**SYDNEY WEST CENTRAL PLANNING PANEL  
COUNCIL ASSESSMENT REPORT**

<b>Panel Reference</b>	2016SYW017
<b>DA Number</b>	DA/728/2016 (formerly Auburn Council ref: DA-465/2015)
<b>LGA</b>	City of Parramatta (formerly Auburn Council)
<b>Proposed Development</b>	Demolition of existing buildings, subdivision of the site to create 4 lots and construction of a mixed use development on Block A comprising 396 residential apartments and 2 commercial tenancies with building heights ranging between 4-8 storeys and a 16 storey tower, car parking for 478 vehicles, public domain works and landscaping.
<b>Street Address</b>	6-8 Baywater Drive, WENTWORTH POINT NSW 2127 (Lot 18 DP 270113)
<b>Applicant/Owner</b>	Tier Architects / Homebush Bay Holdings Pty Ltd
<b>Date of DA lodgement</b>	22 December 2015
<b>Number of Submissions</b>	Public Submissions (20) & Public Meeting (33 attendees)
<b>Recommendation</b>	Approval subject to conditions.
<b>Regional Development Criteria (Schedule 4A of the EP&amp;A Act)</b>	Pursuant to Clause 3 of Schedule 4A of the Environmental Planning and Assessment Act 1979, the development has a capital investment value of more than \$20 million.

<b>List of all relevant s79C(

**Figure 6. Dedication of open space as part of Block B.**

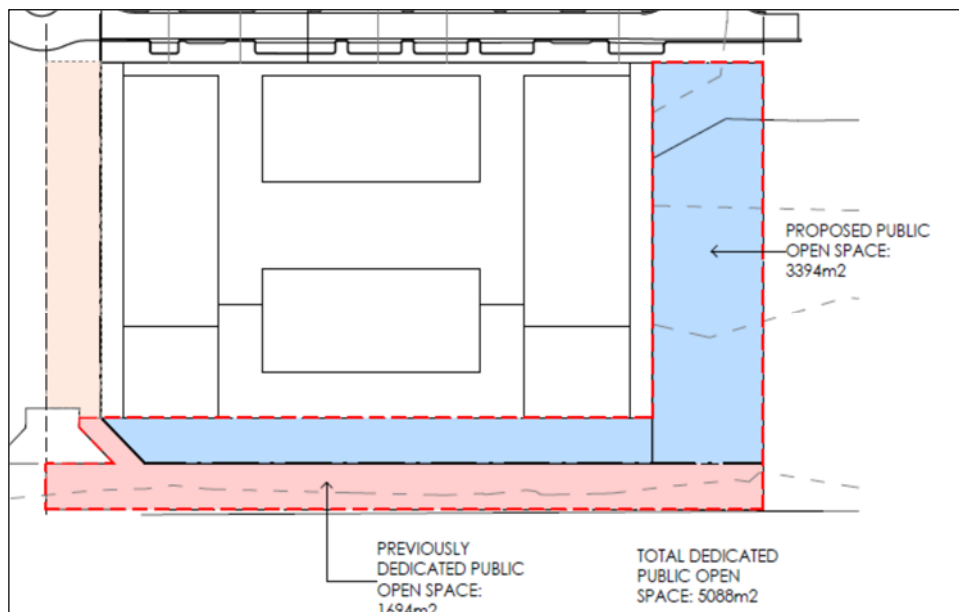
The HBW DCP requires that Precinct E provide 5,075m<sup>2</sup> of public open space in the form of a foreshore promenade and an ‘urban plaza’ at the terminus of Nuvolari Place. Concern was raised as to the ability of Block B being able to achieve the Public Open Space area for the entirety of Precinct E, given that the existing Baywater site and subject application do not incorporate any public open space. The applicant has provided a diagram, below, which demonstrates that the proposed urban plaza and foreshore promenade (being 3394m<sup>2</sup>) and the existing foreshore walkway (already dedicated as public open space 1694m<sup>2</sup>) will be sufficient to cater for the public open space area required for the precinct.

The proposal does not provide detail of how the new public domain areas will be landscaped. The foreshore promenade was not upgraded to the standard outlined in the current DCP at the time it was dedicated to community title. This information has been provided as part of the concurrent application for development of Block B. Conditions of consent will be included in that consent to ensure the public domain areas are appropriately landscaped and upgraded.

**Figure 7. Extract from Homebush Bay West DCP 2004 Amendment 1 (subject site outlined in red).**

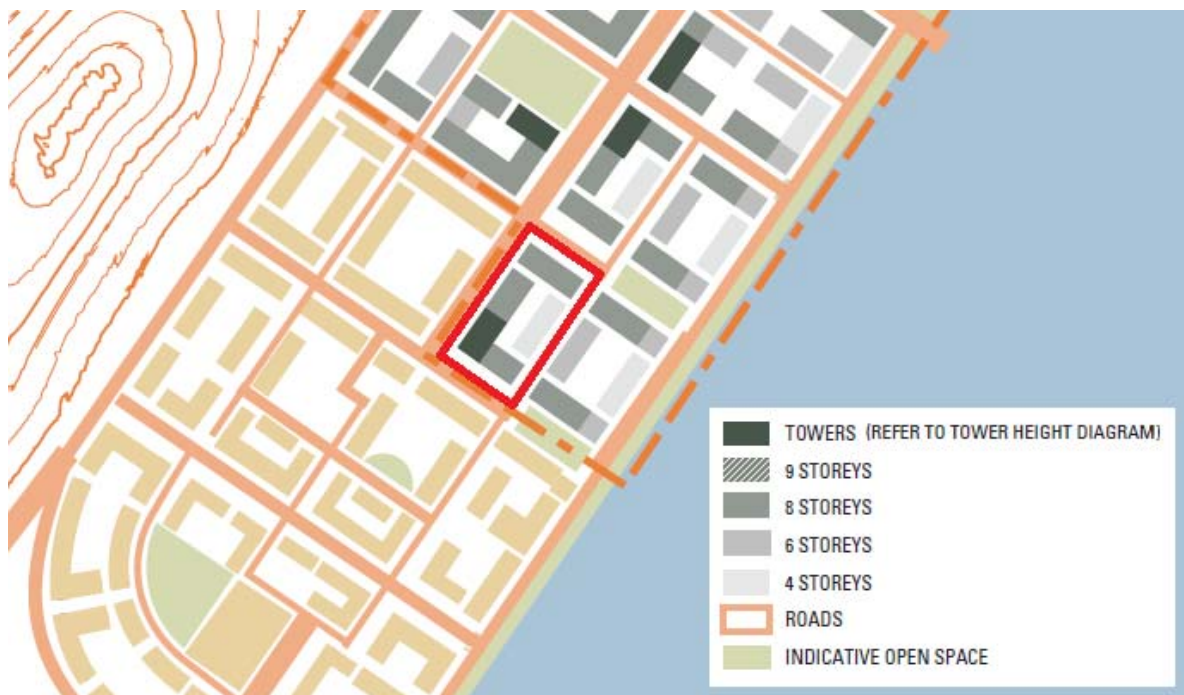
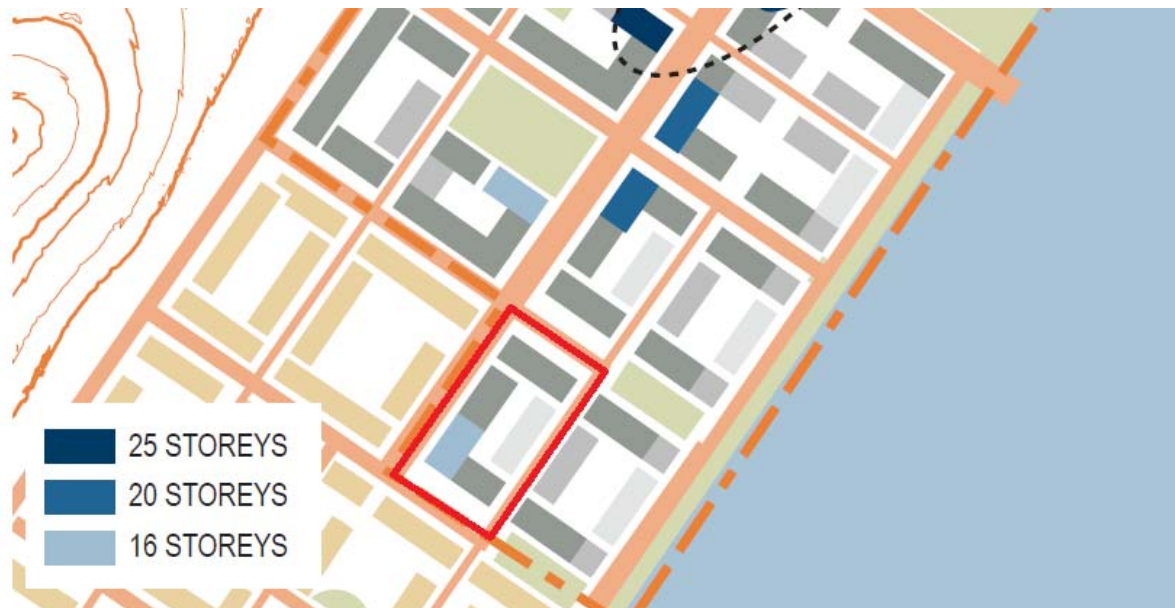
Clause 5.3.2 of Homebush Bay West DCP Amendment 1 outlines the allowable building heights for the site. The DCP allows 4-16 storeys on the site in accordance with the figures above.

Based on the definition of storeys in the DCP and the proposed site levels the proposal breaches the height limit in several locations (see table below).

The ground floor level, which is composed primarily of car parking, is more than 1200mm above ground level and as such counts as a storey in the above table. While this breach of the control could be resolved by setting the parking level further underground that is not possible on the site due to contamination and water level constraints. While not as wide spread as the alternative floor space interpretation outlined above, there are several examples of development applications in the area in which such ground levels were not included in the height assessment<sup>2</sup>. For these reasons, and as the breach also arises out of the increased parking obligations resulting from Amendment 1 to the HBW DCP, the non-compliance is considered to be justified.

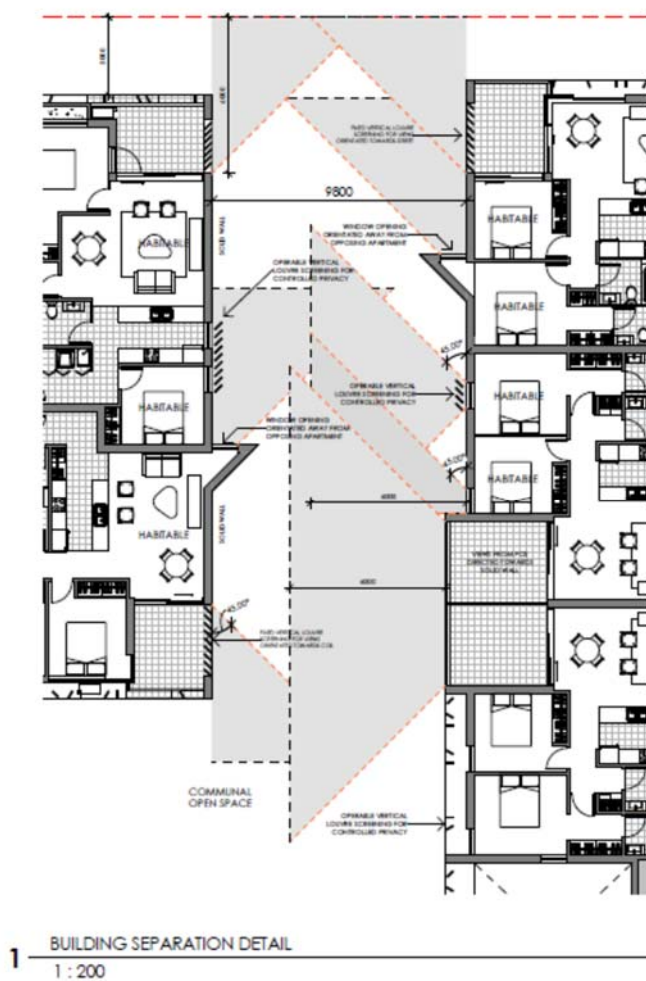
The proposal incorporates a built form setback of 3 metres for Monza Drive, 3 metres for Marine Parade and 5 metres for both Baywater Drive and Nuvolari Place with the exception of the ground floor, where in some instances a setback of 0 metres is provided to ground floor terraces. The applicant has noted that, although strict numerical compliance is not achieved with the amended plans, they are consistent with the existing context and built forms in the locality. The amended plans show a suitable interface with the public domain, with the provision of stepped planter boxes provided between private entries to ground floor units for the majority of the street frontage

Suitable documentation has been provided to demonstrate that encroachments on the ground floor have been consistent within the locality. Given that the encroachment relates to the ground floor terraces only (being softened by a 1-2m landscaped buffer) and not the main building form, it is considered that this minor departure is considered acceptable in this instance.
